MOSSMAN COMMUNITY INFRASTRUCTURE UPGRADES RESPONSE TO REQUEST FOR INFORMATION

On behalf of our client, Department of Aboriginal and Torres Strait Islander Partnerships, with reference to the Confirmation Notice & Information Request (OP2417/2017), we provide the following responses to your request (*in blue italics*) for your consideration.

1020 – Mossman Gorge Community Infrastructure Upgrades

Water Reticulation

Client		DATSIP	
Project		MOSSMAN GORGE INFRASTRUCTURE UPGRADES	
Title		STORMWATER CATCHMENT PLAN	
JOB No.	Scale (A1 size)	Date	Drawing No.
1020	1:750	29 MARCH 2018	SKETCH 1020-004
Revision			A

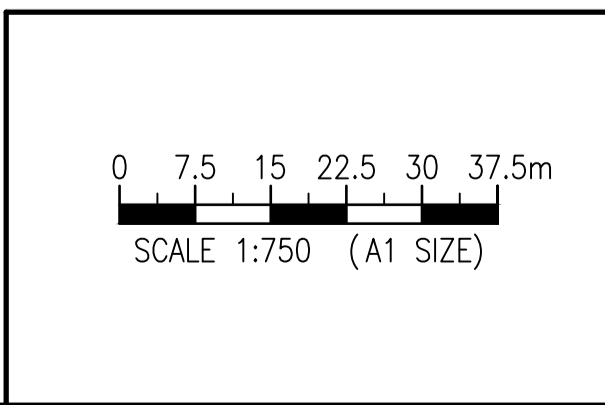
6. Stormwater system calculations and a catchment plan are to be provided.

Please see attached stormwater drainage catchment plan and calculations.

Figure 1: Reproduction of 1020-SKETCH-1 showing the node layout of the EPANET model representing the existing network.

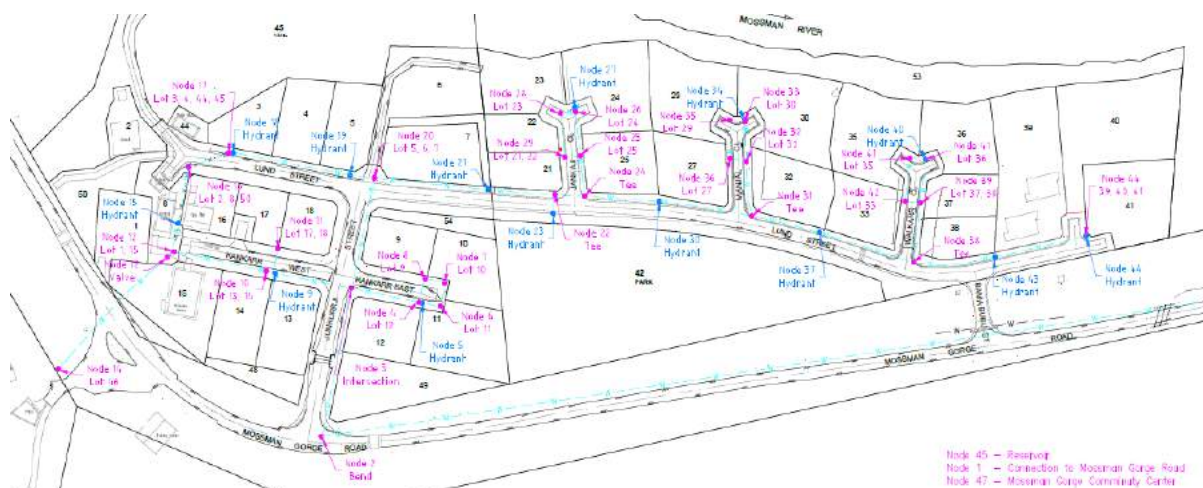
1. Please provide pressure and flow test results on Mossman Gorge Road to allow for calibration of the water network model.
2. A water supply network analysis incorporating pressure and flow tests is to be provided.
3. Confirmation whether a booster pump station is required. The determination of the booster pump is to have regard to the results of the water supply network analysis.

The water reticulation system for Mossman Gorge has been modelled for performance using an EPANET model based on the assumptions outlined below. The existing water reticulation system servicing the Mossman Gorge Community involves pipelines with diameters ranging from 25 mm to 150 mm. The Mossman George Community water reticulation system draws from the Mossman reservoir located on George View Crescent via a 150 mm diameter main along Mossman George Road.

For the purpose of the model, 90 m AHD was adopted as the connection pressure (being 2.2 m below the reservoir’s advised top water level).

Hydrant flow tests as received from Gilboy Hydraulic Solutions

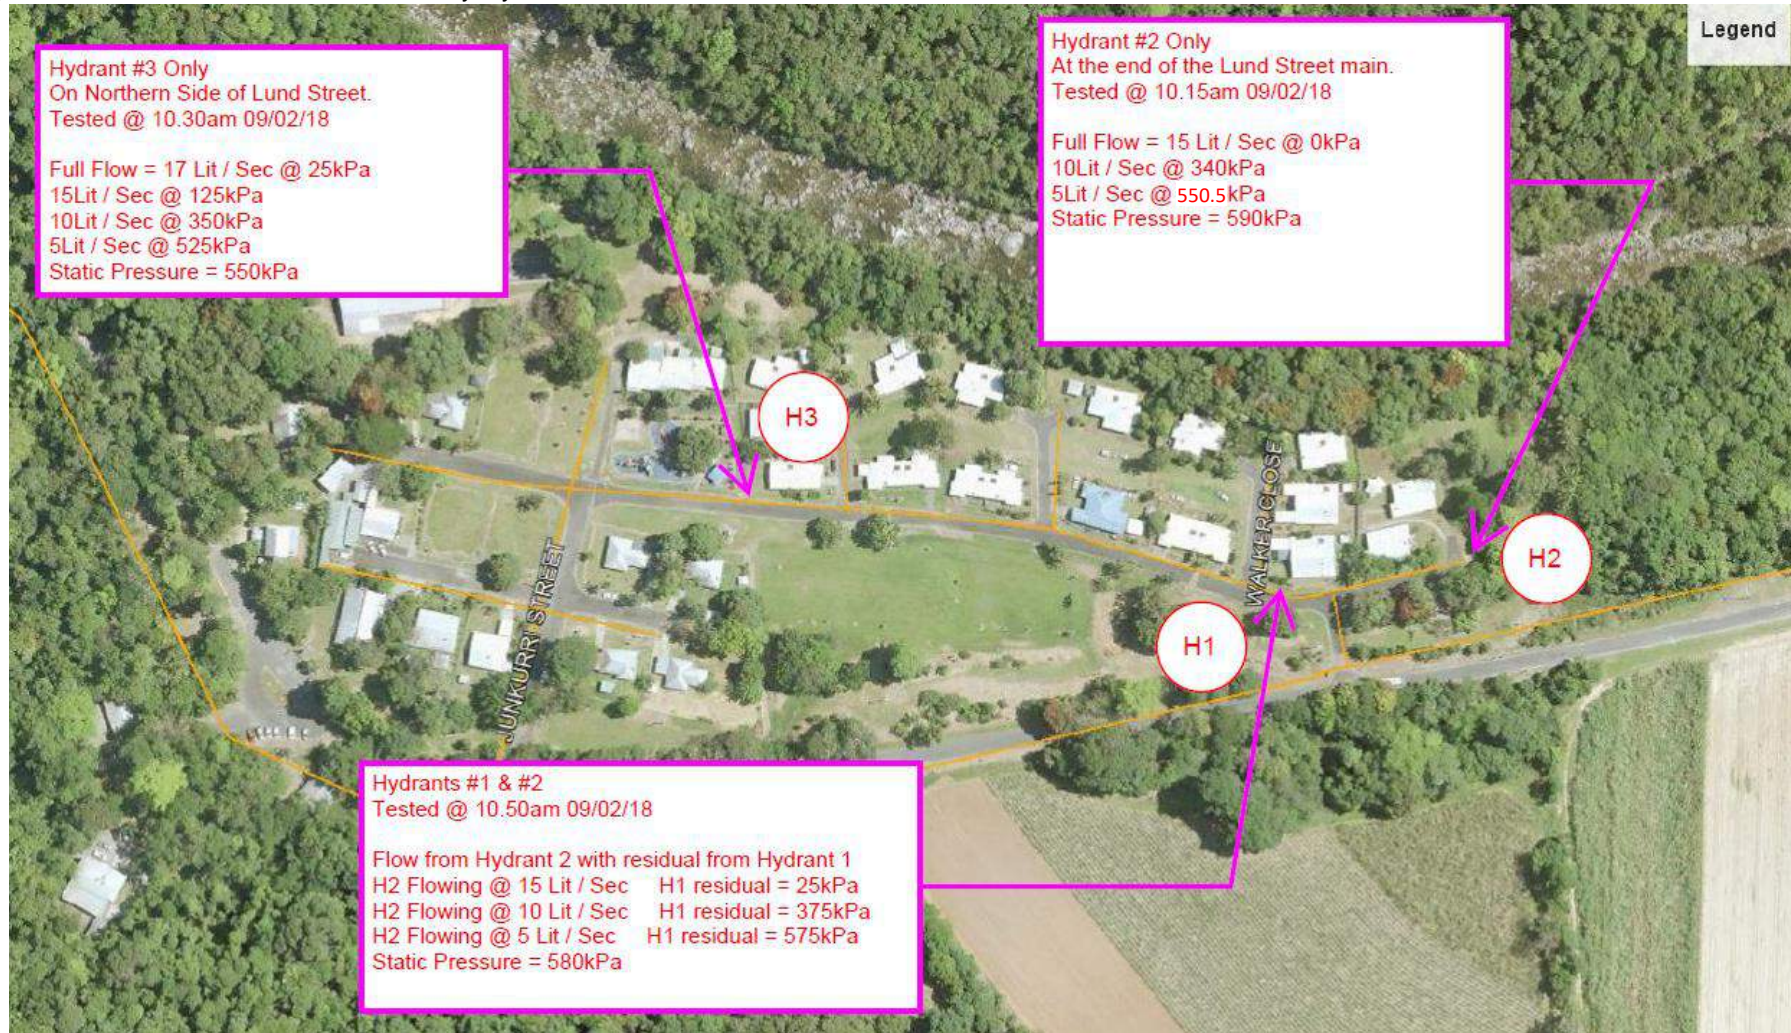
1. Please provide pressure and flow test results on Mossman Gorge Road to allow for calibration of the water network model.

TEC Response: Hydrant pressure and flow tests were conducted by Gilboy Hydraulic Solutions in February 2018, refer Appendix B. Advice given, stated the achievable flows from the three tested hydrants were between 15 L/s and 17 L/s, residual pressures however, were not above 12 m head. This does not meet FNQROC Guidelines (Section D6). The measured static pressures enabled for back analysis of the reservoir water level location, the calculated water level height was above the Top Water Level (TWL) of the reservoir recorded in a council report.

Earlier testing conducted in August 2017 indicated similar static levels to that of the TWL of the Mossman Reservoir #2. The 2017 results under flow conditions vary from the 2018 results. In discussions with Council Officers it was determined that these (August 2017) tests were undertaken whilst the mains were undergoing maintenance and therefore resulted in low flows and residual pressures. The 2017 flow tests are therefore not considered representative of normal system operating conditions.

Client		DATSIP	
Project		MOSSMAN GORGE INFRASTRUCTURE UPGRADES	
Title		WATER RETICULATION LAYOUT	
		SHEET 1 OF 2	
Drawing Check	Design Check	Approved	
RPEQ	Date	Drawing No.	Revision
		1020-028	C

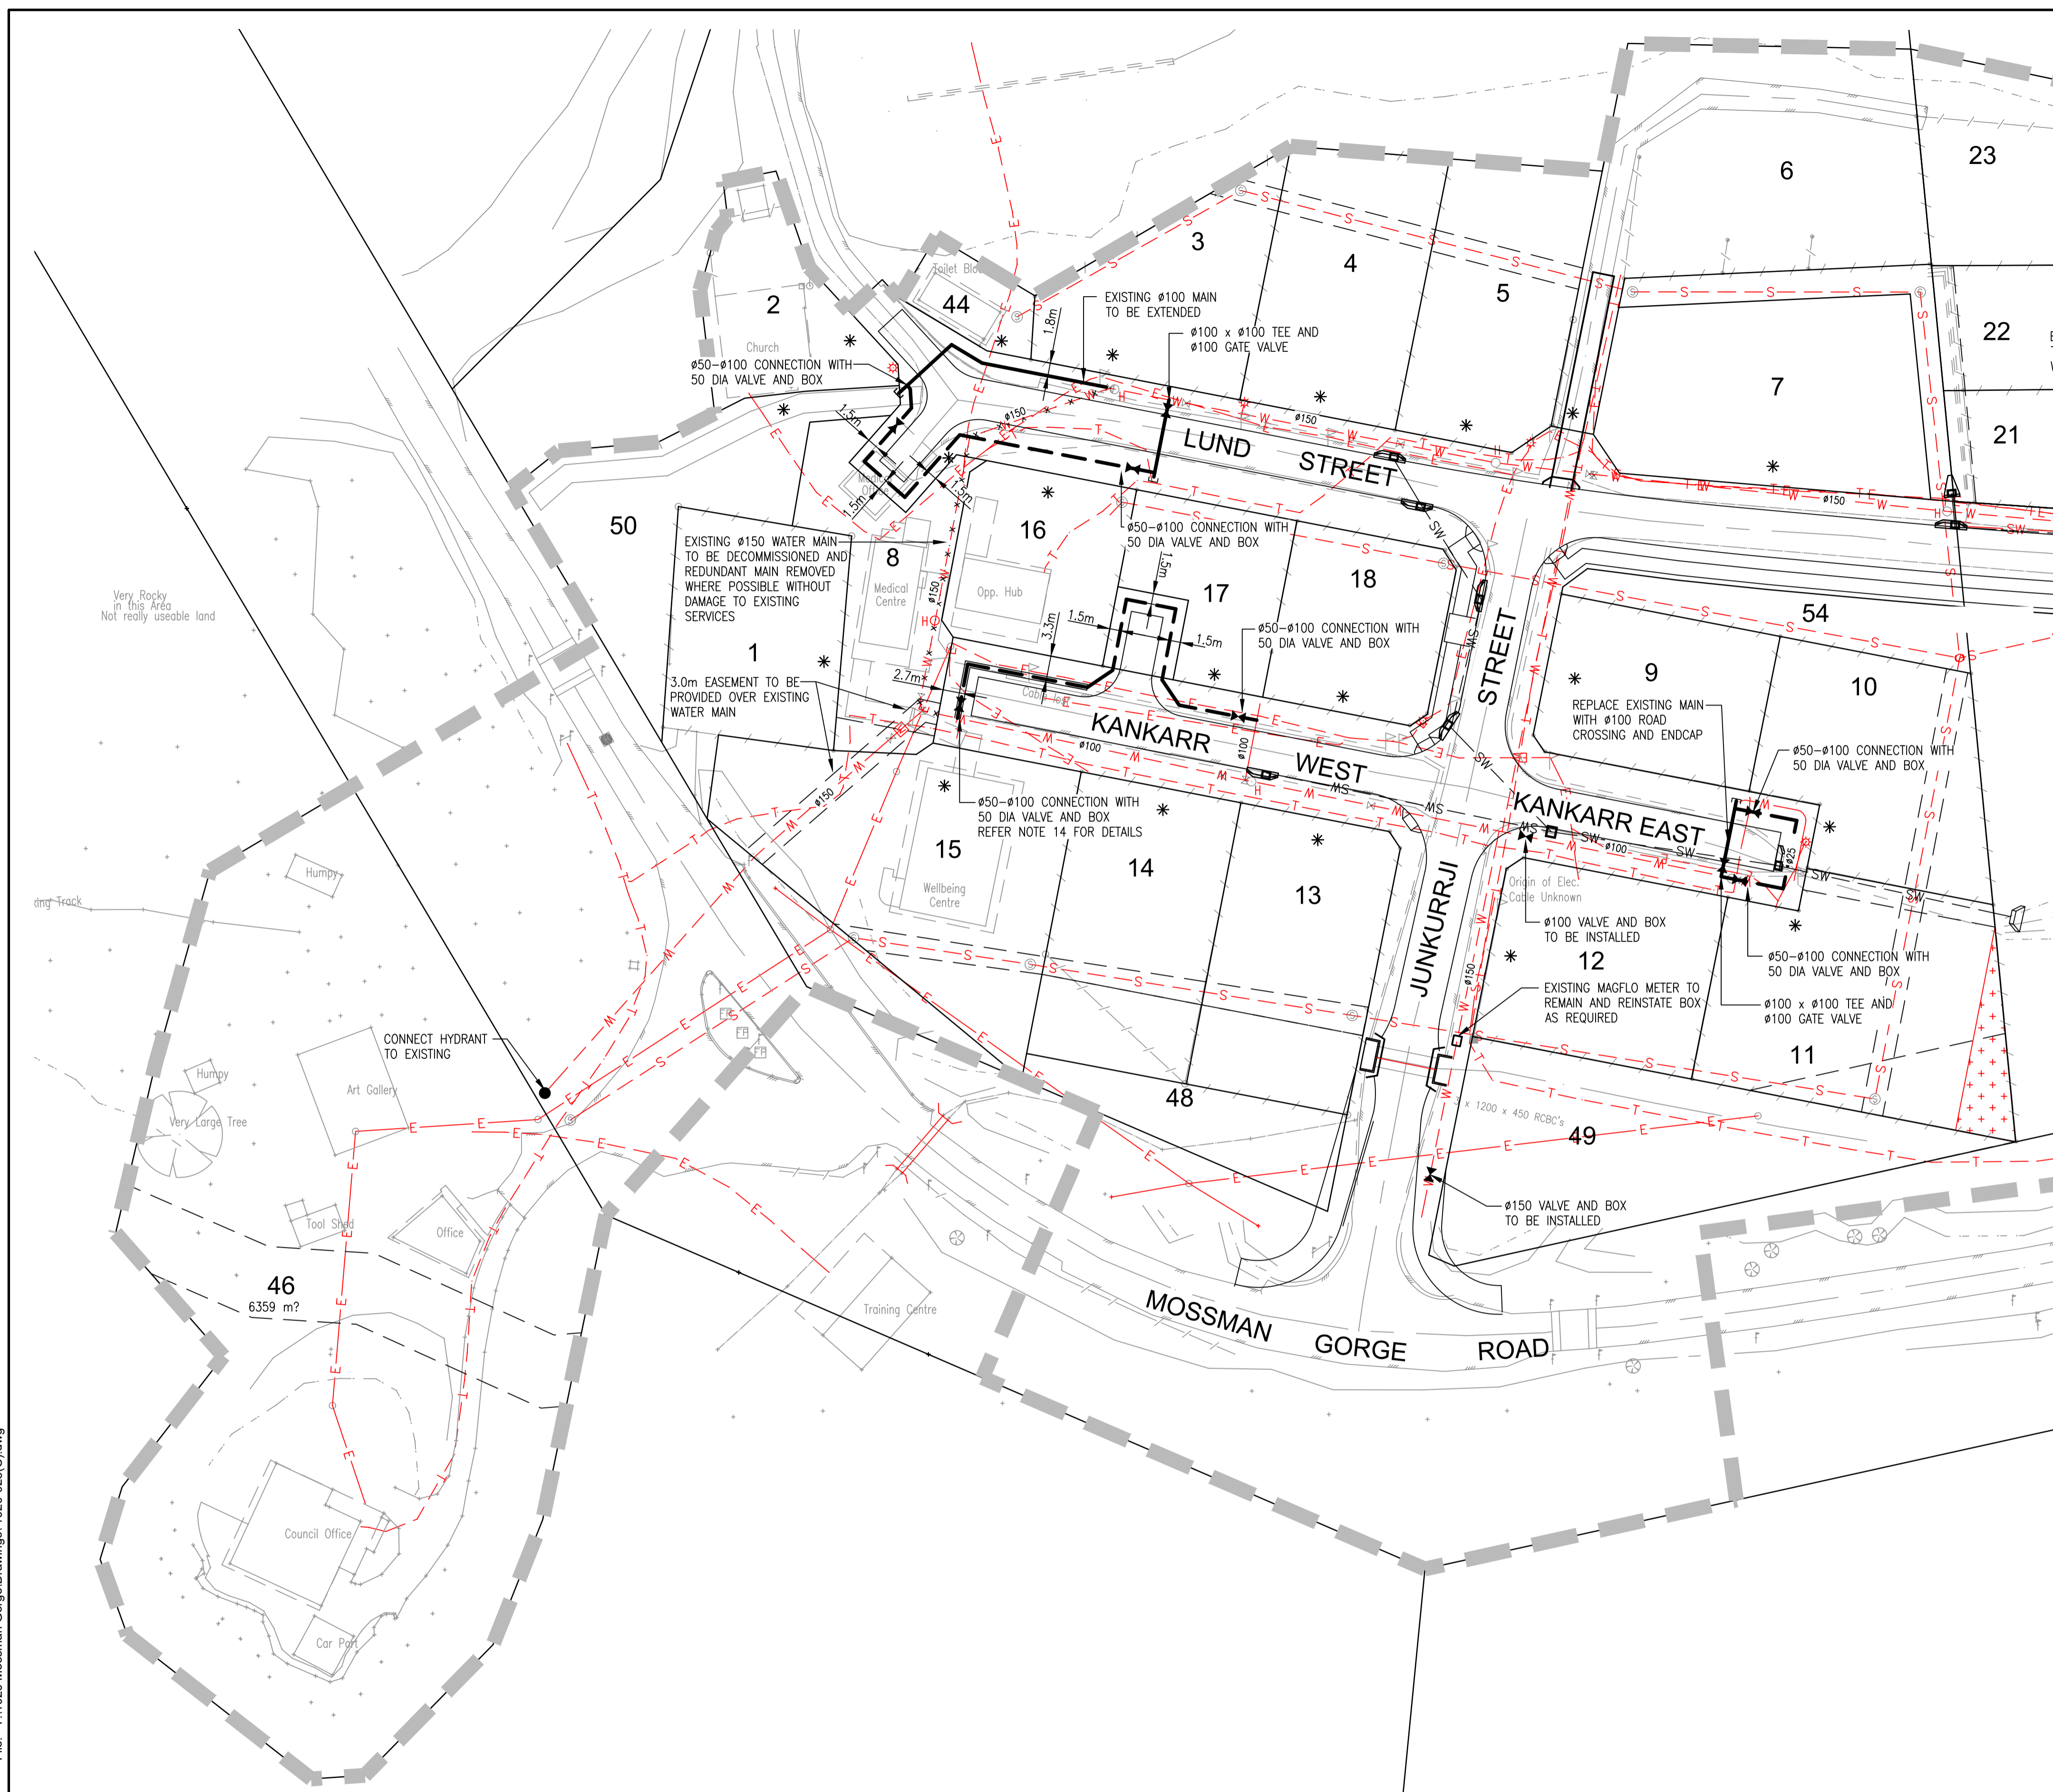
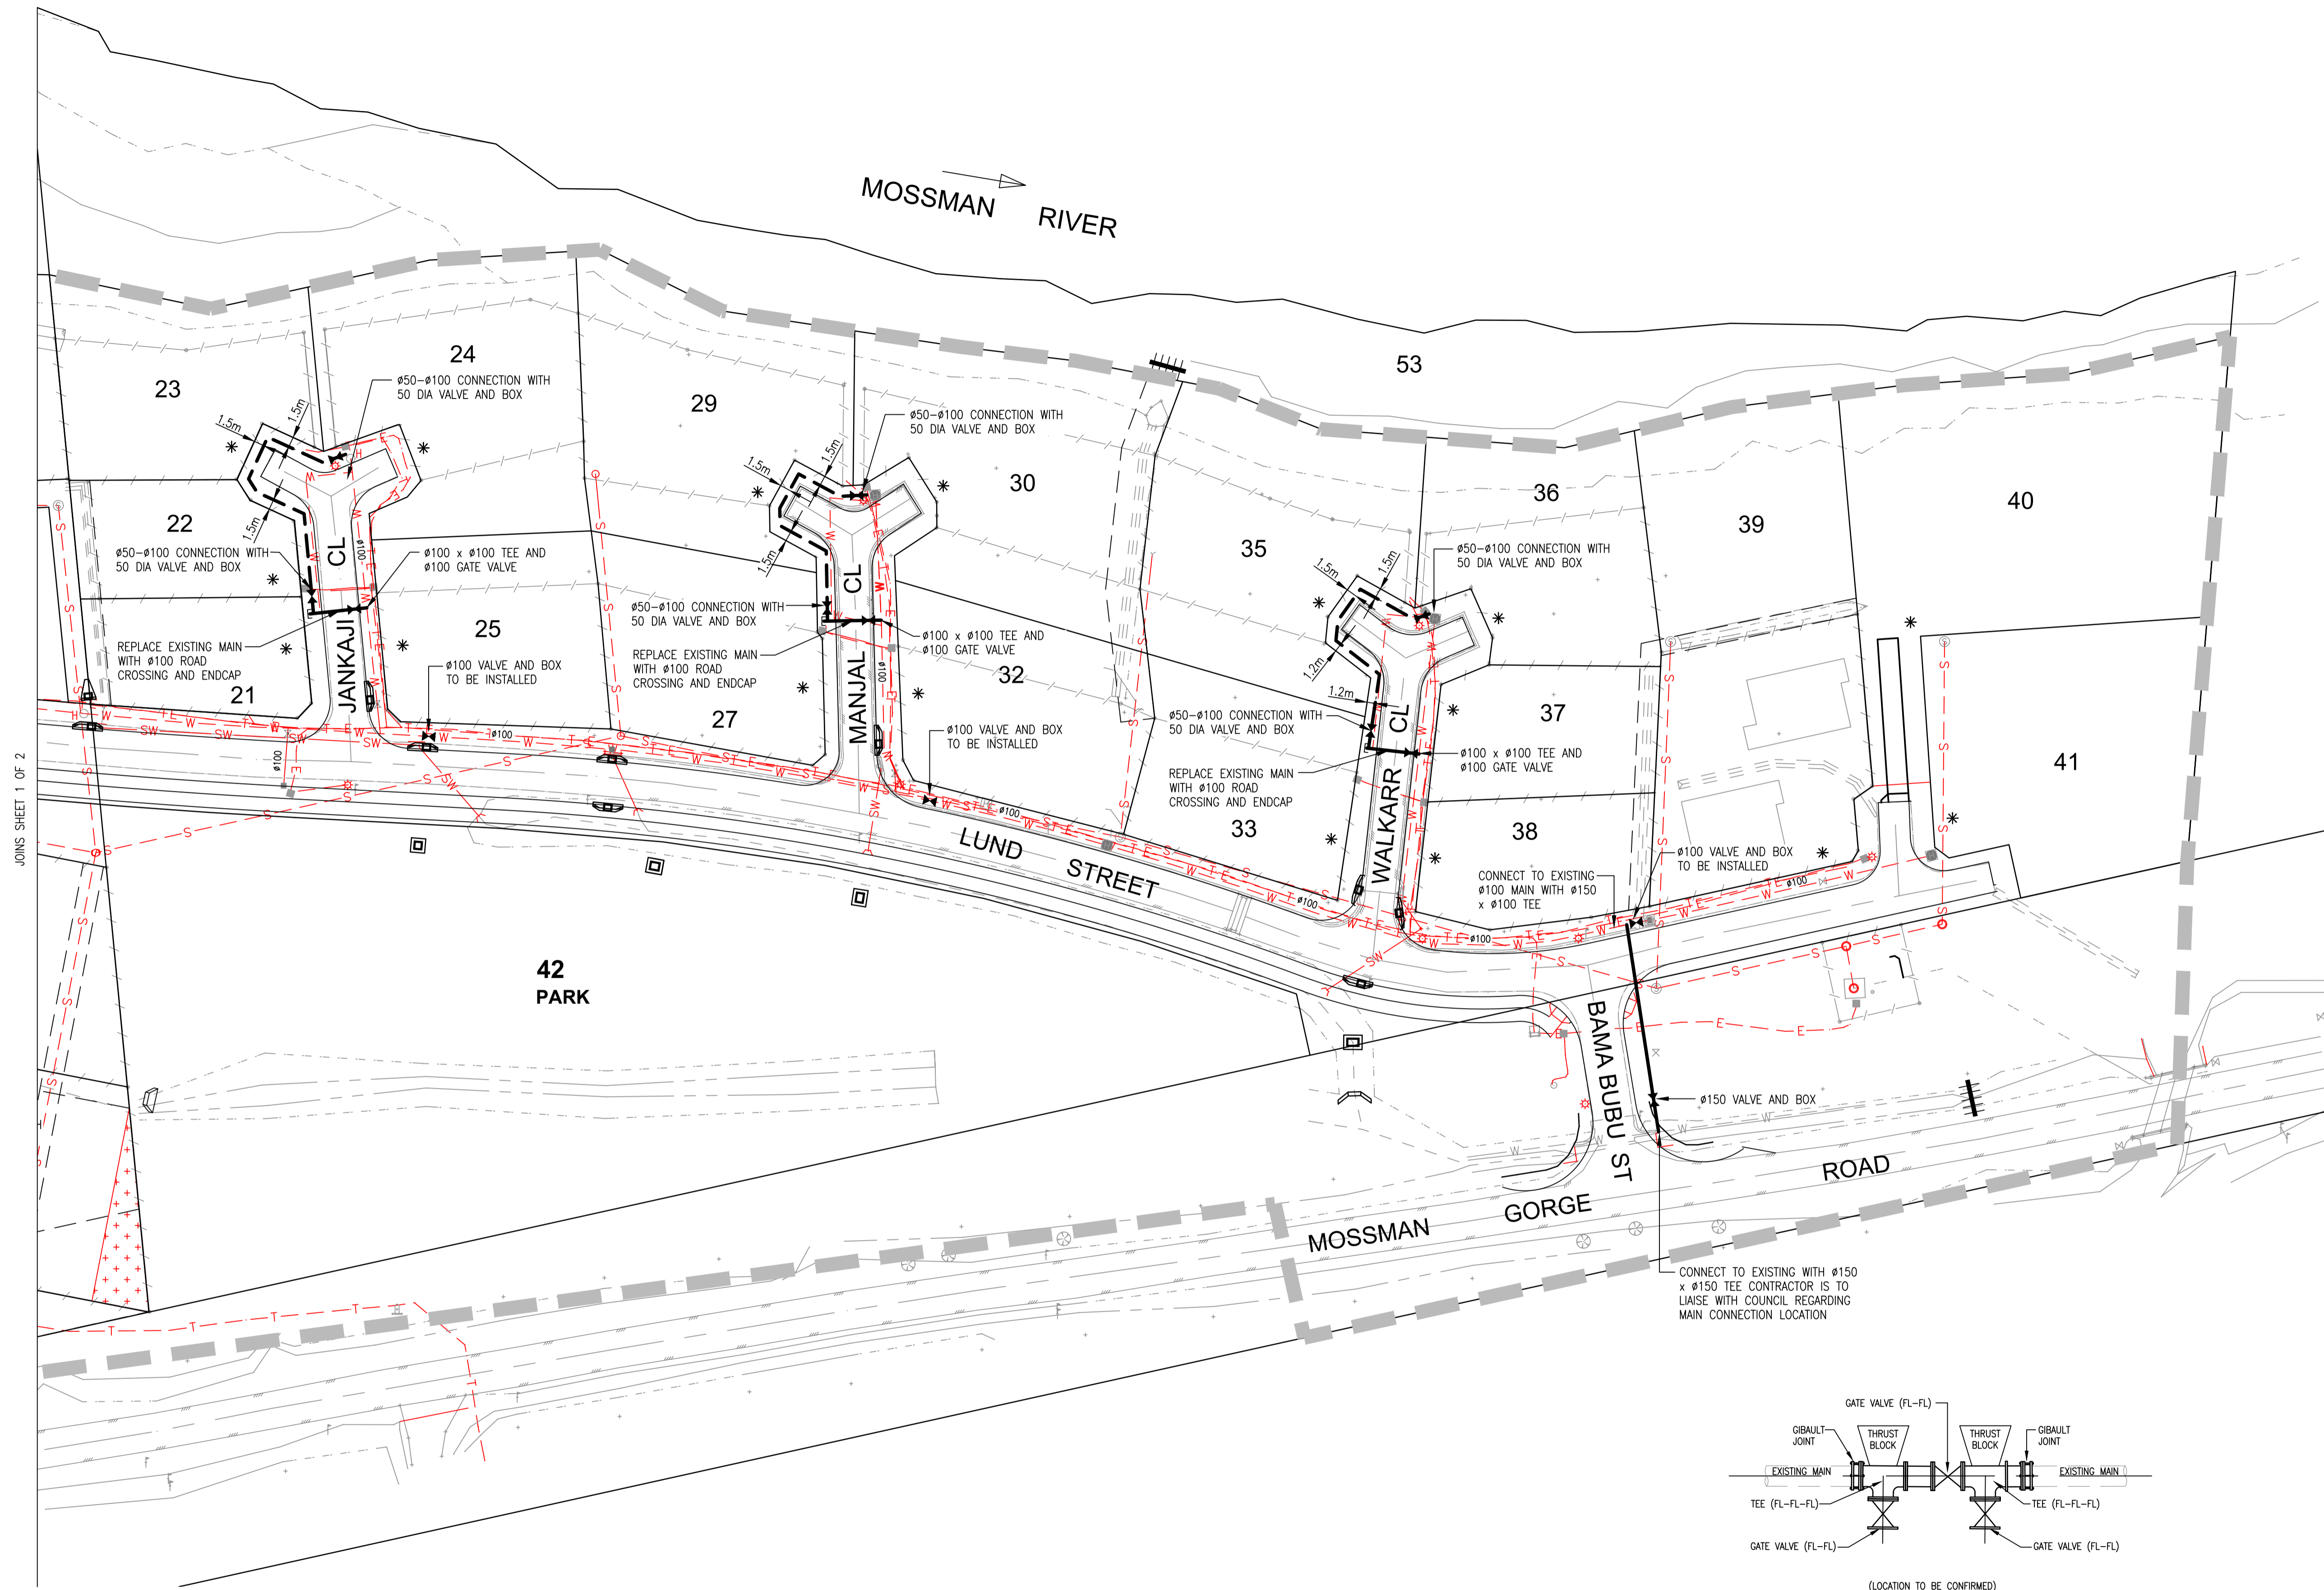
3. Confirmation whether a booster pump station is required. The determination of the booster pump is to have regard to the results of the water supply network analysis.

The proposed changes are illustrated on engineering drawings 1020-028 and 029 (Appendix F). The major changes are summarised as follows;

- 150 mm diameter connection from Mossman Gorge Road to East Lund Street via Bama Bubu Street, (proposed for capacity under fire fighting);
- Decommissioning of pipeline between medical centre and Opp hub and construct local loop main, (proposed for land tenure reasons);
- Hydrant connection at BBN carpark; and
- Replace 25 mm diameter pipelines with 50 mm diameter pipelines, (proposed for operational reasons and minimum pipe sizes).

TEC Response: A booster pump station may be installed if Council requires that all FNQROC guidelines to be met.

- *Duplicate 925m of the 150 mm watermain (or replace with a 225 mm watermain) prior to the Mossman George Community; or*
- *Duplicate 700 m of 150 mm main (or replace with 225 mm watermain) and connect the main along Mossman Gorge Road (node 2) to the carpark hydrant (node 14) with a 150 mm pipe; or*
- *Construct a booster pump station to provide 10 m of additional head.*
